ADDENDUM #3

GADSDEN CITY HALL

Gadsden, AL WBA #23-083.00

DATE: 13 December 2024

MECHANICAL - 1ST FLOOR PLAN - CITY COUNCIL
SCALE: 1/8" = 1'-0"

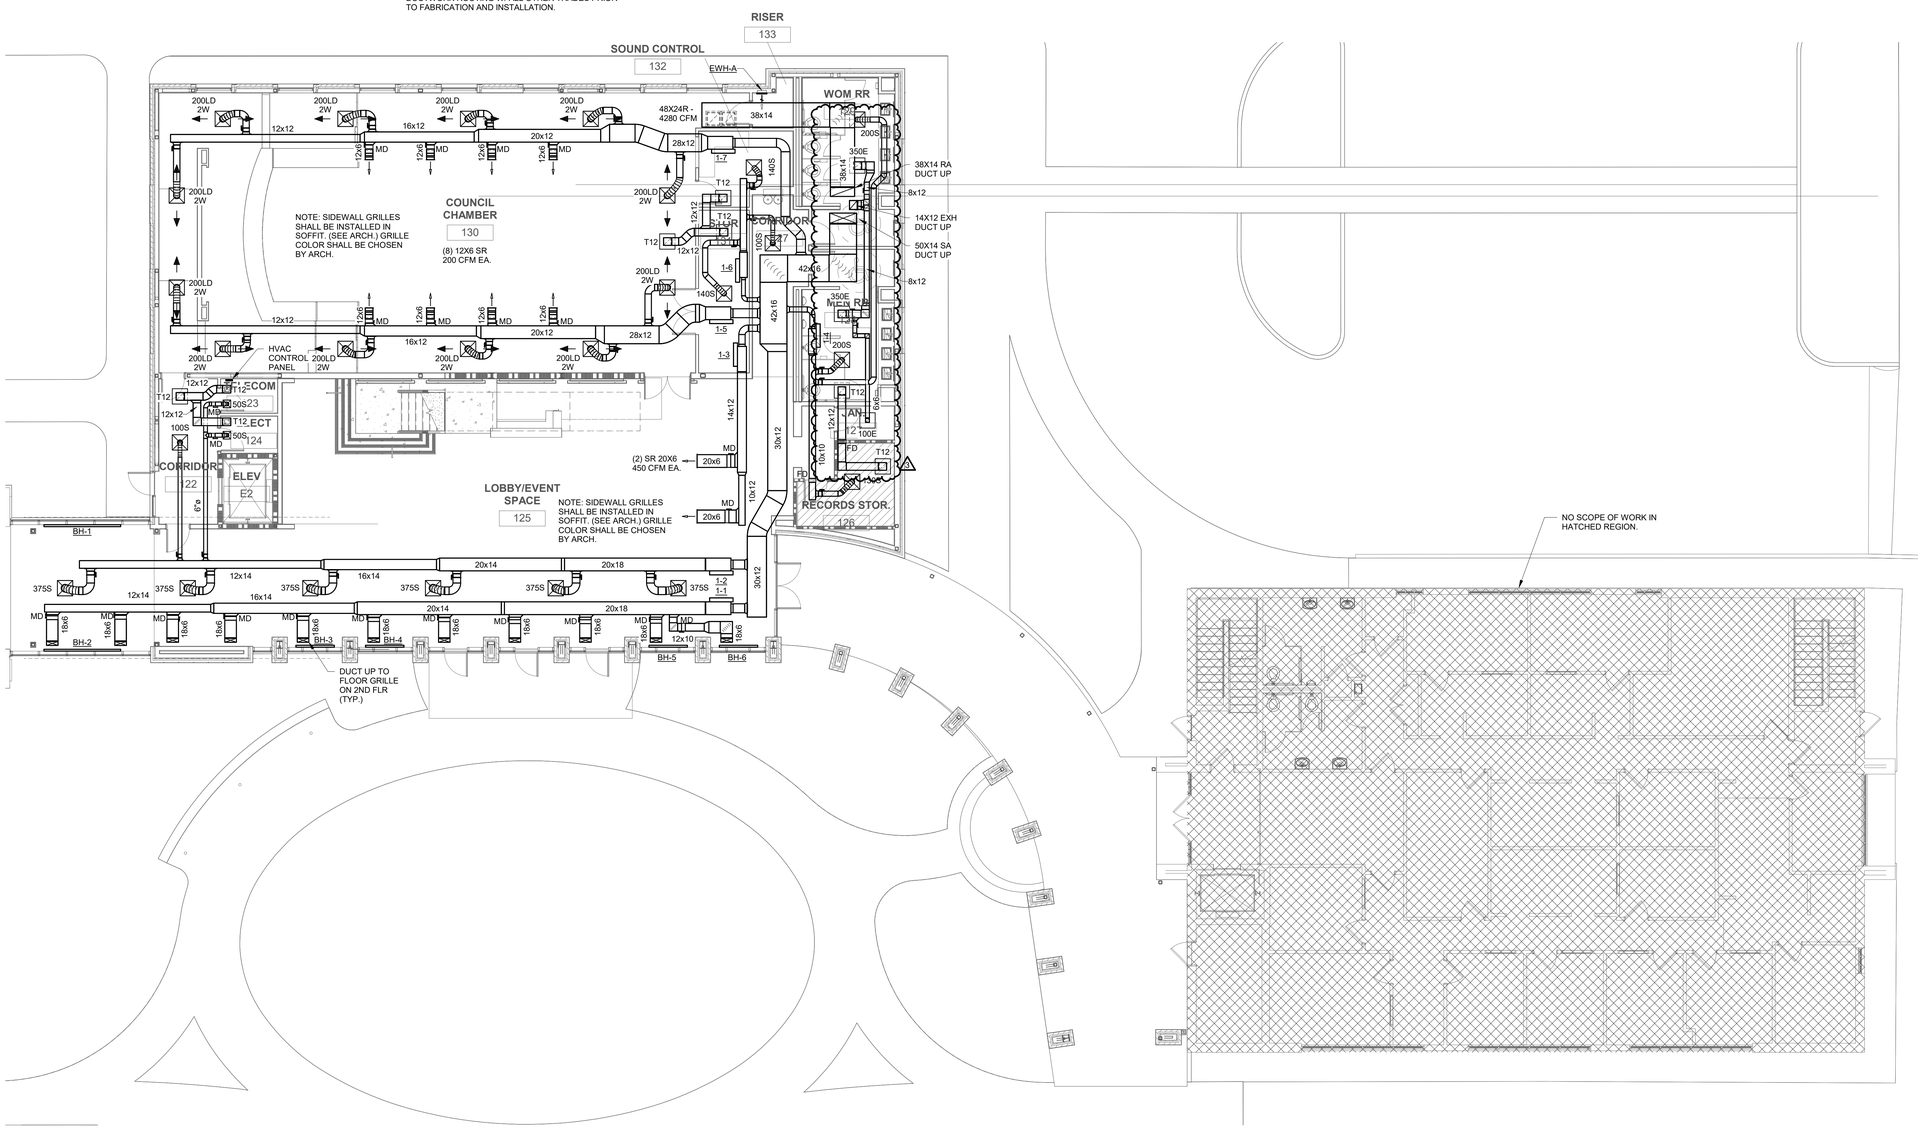
45. **Sheet M-202 – MECHANICAL – 1ST FLOOR PLAN – CITY COUNCIL:**
    a. Drawing 1/M-202 – MECHANICAL 1st FLOOR PLAN – CITY COUNCIL: Moved ductwork to coordinate with wall and ceiling grid.
    b. See attachments.

SHEET NUMBER:
M-203

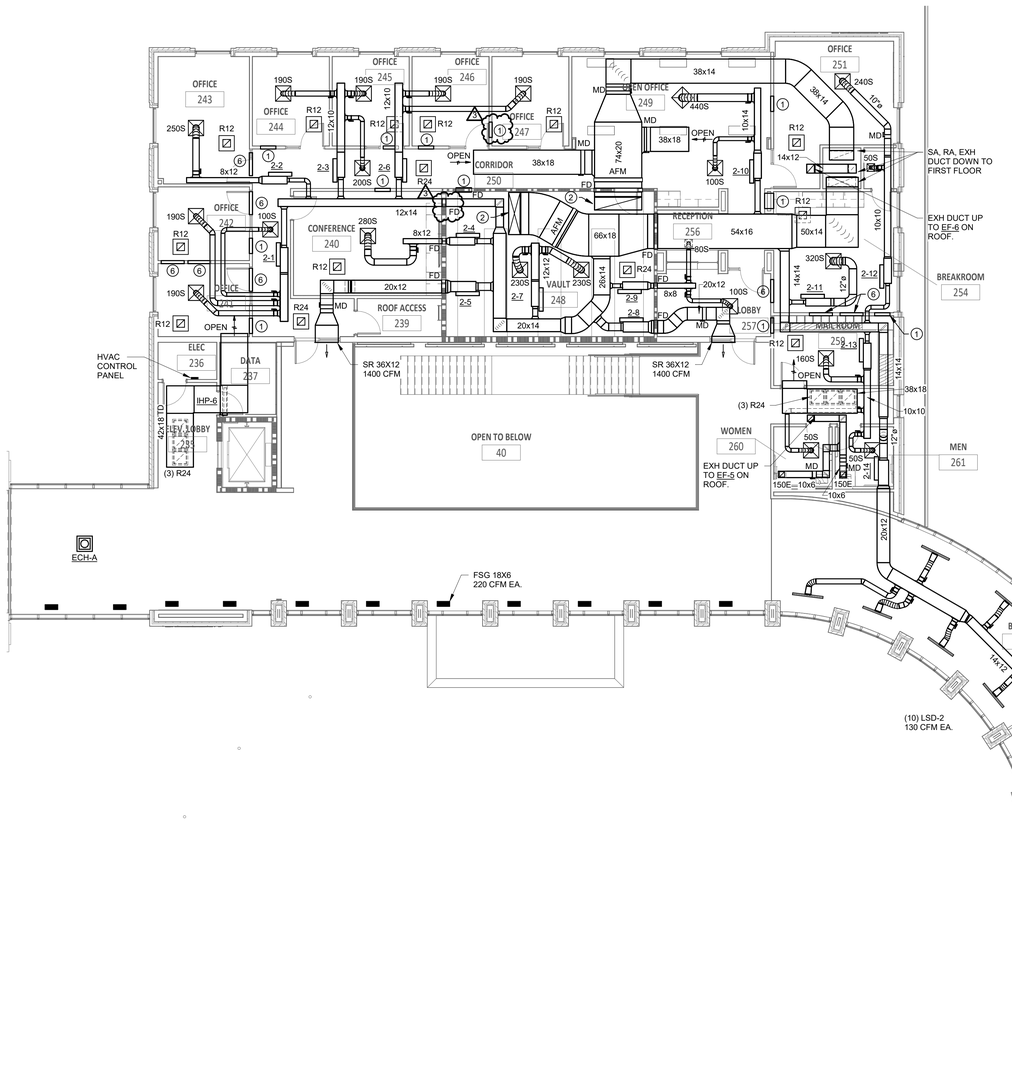
46. **Sheet M-203 – MECHANICAL – 2nd FLOOR PLAN – CITY COUNCIL:**
    a. Drawing 1/M-203 – MECHANICAL – 2nd FLOOR PLAN – CITY COUNCIL: Provided fire damper in supply air duct. Moved return air opening above Office 247.
    b. See attachments.

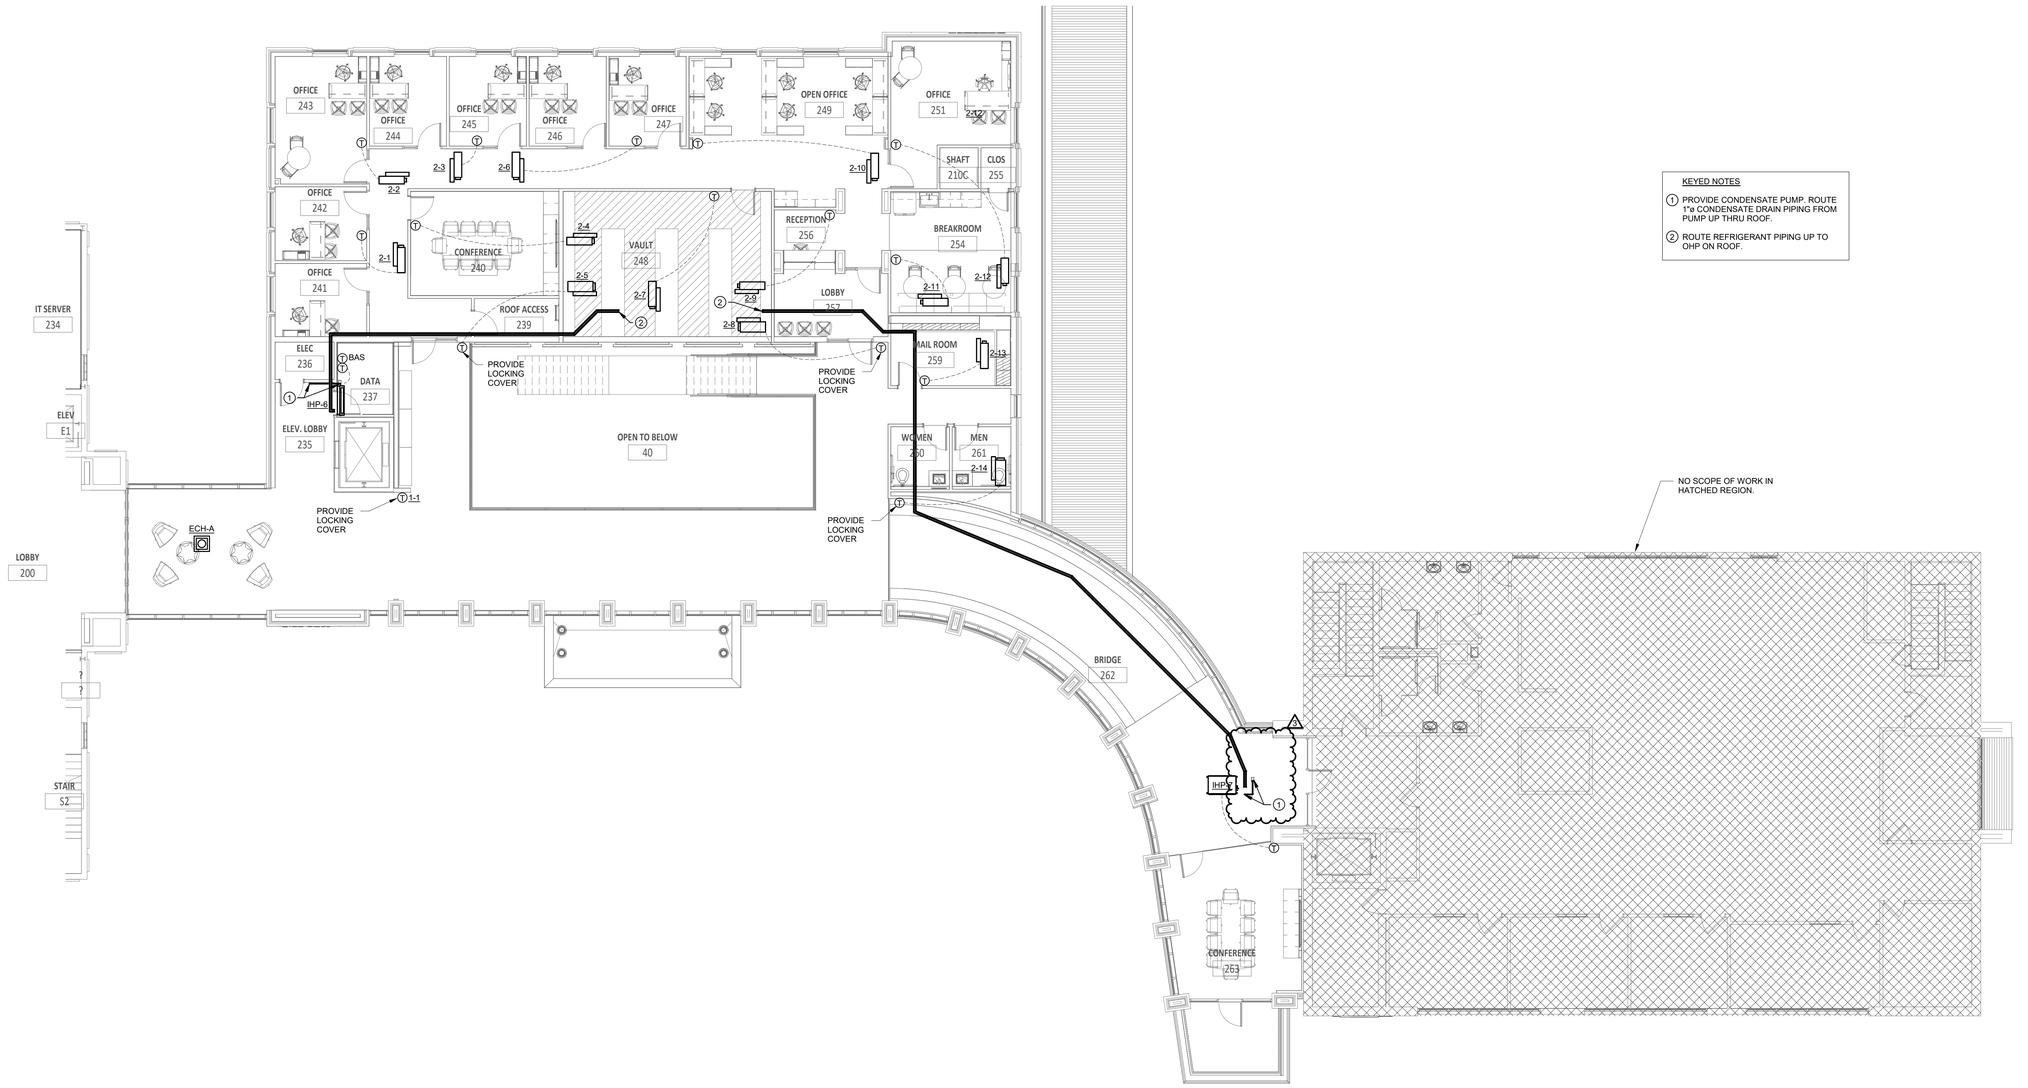
47. **Sheet M-303 – MECHANICAL PIPING – 2nd FLOOR PLAN – CITY COUNCIL:**
    a. Drawing 1/M-303 – MECHANICAL PIPING – 2nd FLOOR PLAN – CITY COUNCIL: Condensate and refrigerant pipe routed to IHP-7.
    b. See attachments.

1 NON-PRESSURE PIPING - 3RD FLOOR PLAN - CITY HALL
SCALE: 1/8" = 1'-0"
NORTH

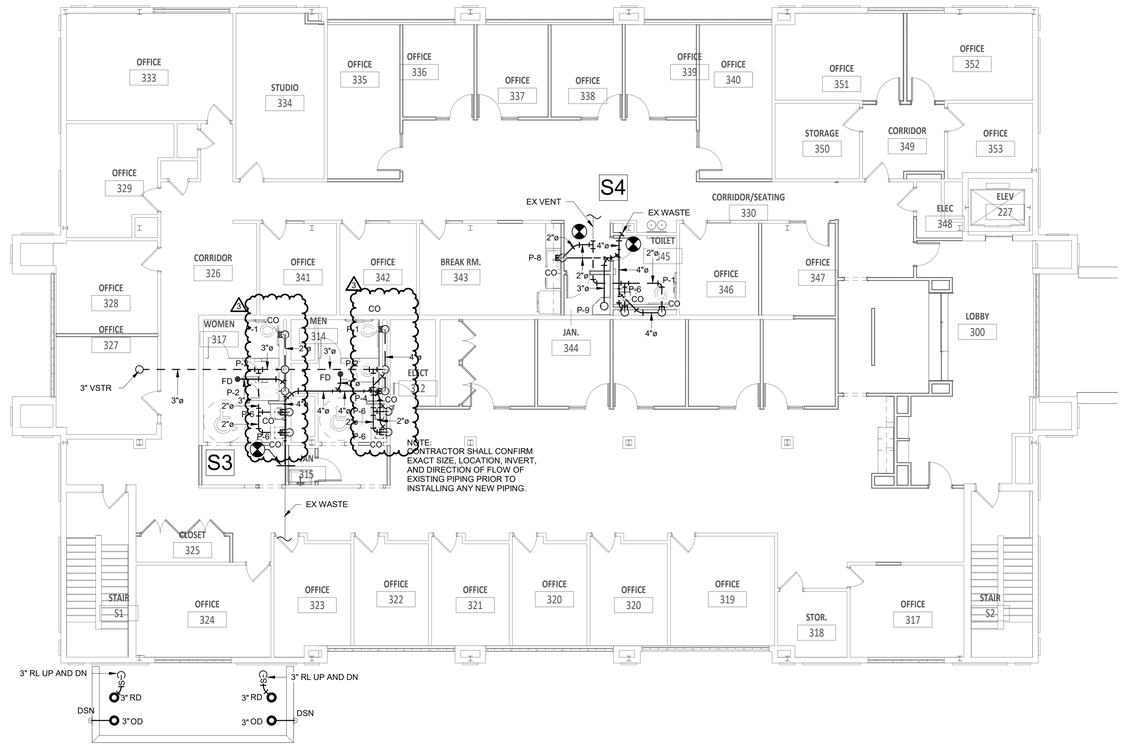
50. **Sheet P-202 – NON-PRESSURE PIPING – 3rd FLOOR PLAN – CITY HALL:**
    a. Drawing 1/P-202 – NON-PRESSURE PIPING – 3rd FLOOR PLAN – CITY HALL: Added cleanouts in Men 314 and Women 317.
    b. See attachments.

1 PRESSURE PIPING - 2ND FLOOR PLAN - CITY HALL
SCAL 1/8" = 1'-0"
E:

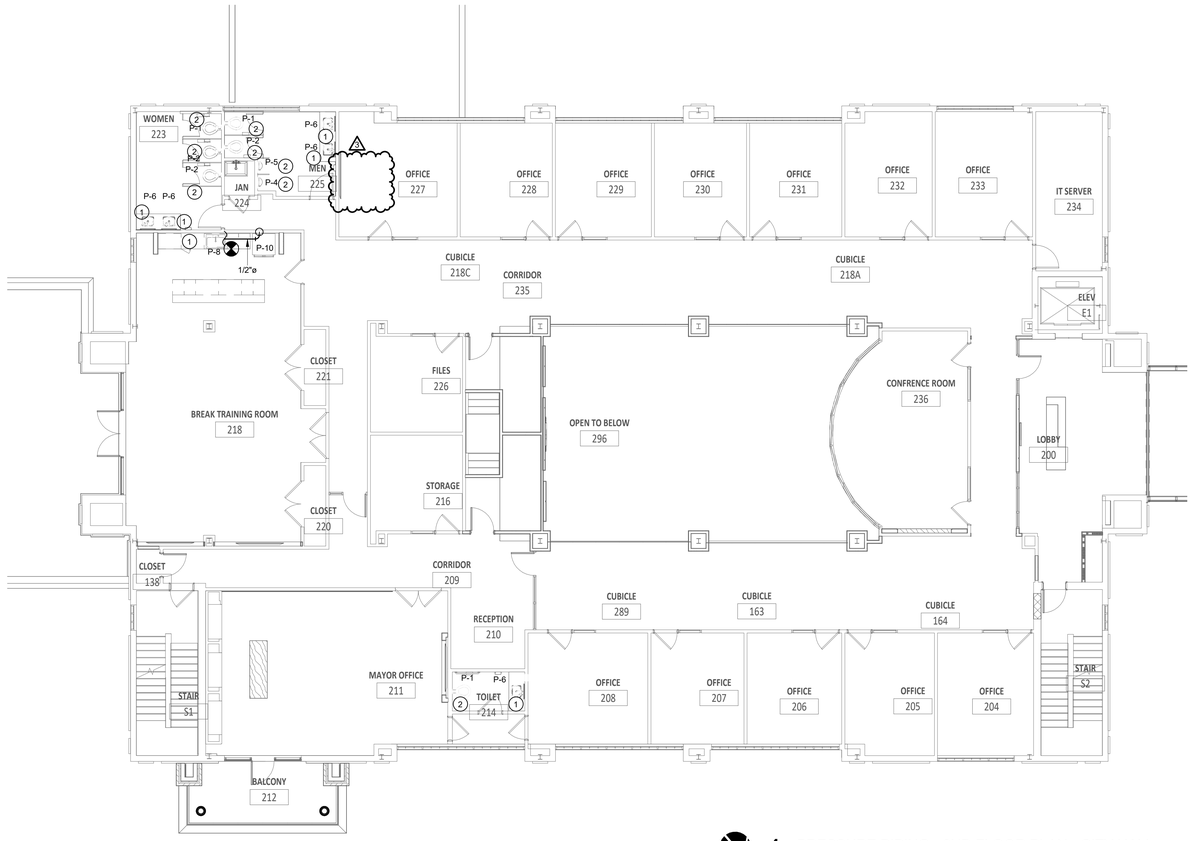
51. **Sheet P-301 – PRESSURE PIPING – 2nd FLOOR PLAN – CITY HALL:**
    a. Drawing 1/P-301 – PRESSURE PIPING – 2nd FLOOR PLAN CITY HALL: Removed riser tag.
    b. See attachments.

1 PRESSURE PIPING - 3RD FLOOR PLAN - CITY HALL
SCALE: 1/8" = 1'-0"
NORTH

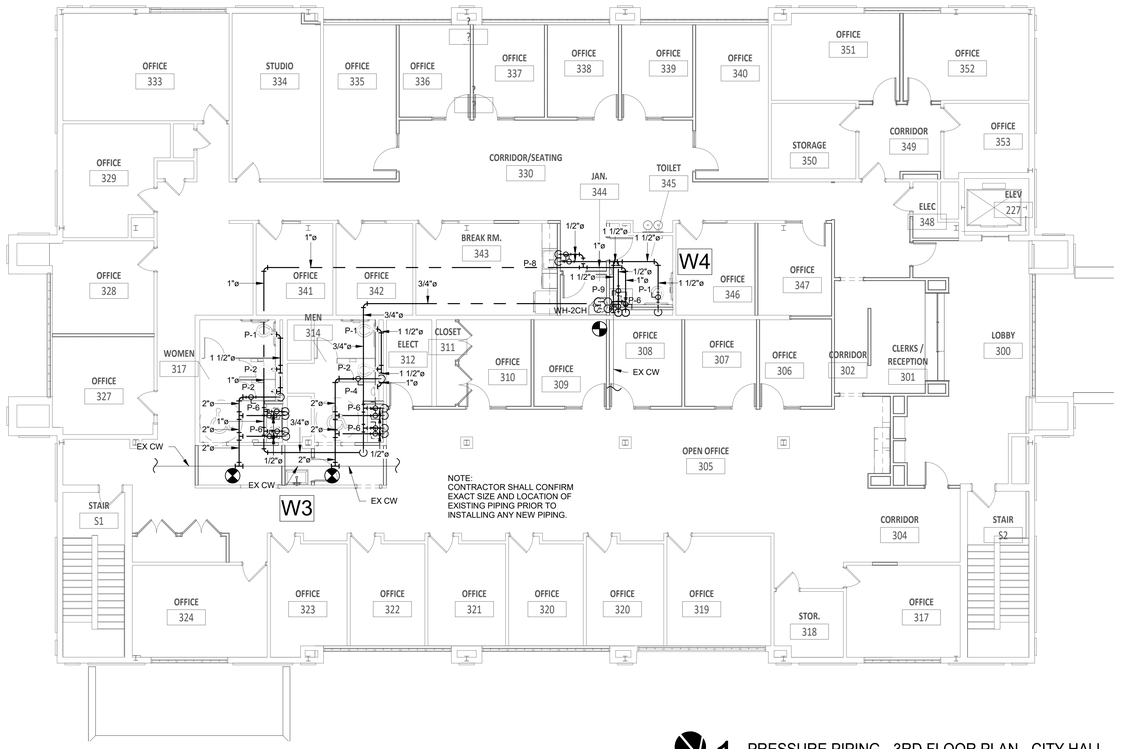
52. **Sheet P-302 – PRESSURE PIPING – 3rd FLOOR PLAN – CITY HALL:**
    a. Drawing 1/P-302 – PRESSURE PIPING – 3rd FLOOR PLAN – CITY HALL: Added riser tag. Added ball valves in vertical drops to mop sink. Added pipe size tag.
    b. See attachments.
